CITY OF CODY
PLANNING, ZONING AND ADJUSTMENT BOARD
TUESDAY, SEPTEMBER 25, 2018
CITY HALL COUNCIL CHAMBERS @ 12:00 NOON

MEETING DATE:	SEPTEMBER 25, 2018	TYPE OF ACTION NEEDED	
AGENDA ITEM:		P&Z BOARD APPROVAL:	X
SUBJECT:	DOWNTOWN ARCHITECTURAL DISTRICT SIGN REVIEW: WYOLD WEST TAP ROOM PROJECTING SIGN. SGN 2018-26	RECOMMENDATION TO COUNCIL:	
PREPARED BY:	TODD STOWELL	DISCUSSION ONLY:

MEETING DATE:	SEPTEMBER 25, 2018	TYPE OF ACTION NEEDED	
AGENDA ITEM:		P&Z BOARD APPROVAL:	X
SUBJECT:	REQUEST FOR 5-FOOT CEDAR PRIVACY FENCE 3114 TWIN CREEK TRAIL AVENUE	RECOMMENDATION TO COUNCIL:	
PREPARED BY:	TODD STOWELL, CITY PLANNER	DISCUSSION ONLY:

MEETING DATE:	SEPTEMBER 25, 2018	TYPE OF ACTION NEEDED	
AGENDA ITEM:		P&Z BOARD APPROVAL:	X
SUBJECT:	SITE PLAN REVIEW: COFFEE STATION SPR 2018-20	RECOMMENDATION TO COUNCIL:	
PREPARED BY:	TODD STOWELL, CITY PLANNER	DISCUSSION ONLY:

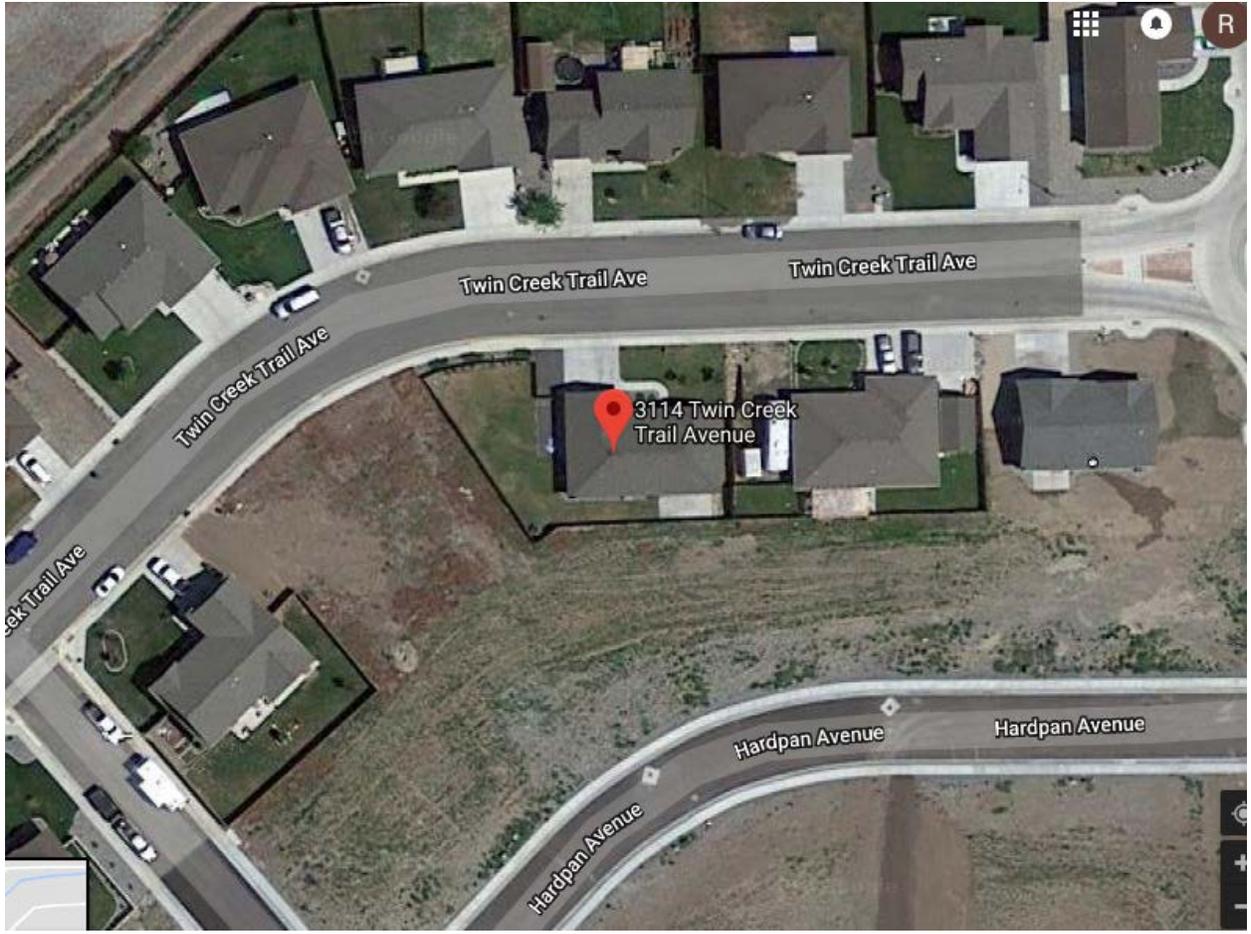
The existing fence, which did have a building permit, is set back 5-6 feet from the sidewalk, which puts it in the City 10-foot utility easement. Fences are not permitted to run parallel down a city utility easement. With the proposed reconstruction of the fence to five feet tall, the fence needs to be moved outside of the utility easement. Doing so also effectively provides a 15-foot sight distance triangle for both the subject property and the neighbor with the vacant lot, which addresses the concern of being able to see oncoming pedestrians and vehicles before backing into the street.

That the height of 5 feet be authorized for the replacement fence, but the fence must be installed to the south of the 10-foot city utility easement. A fence permit from the building official is required.
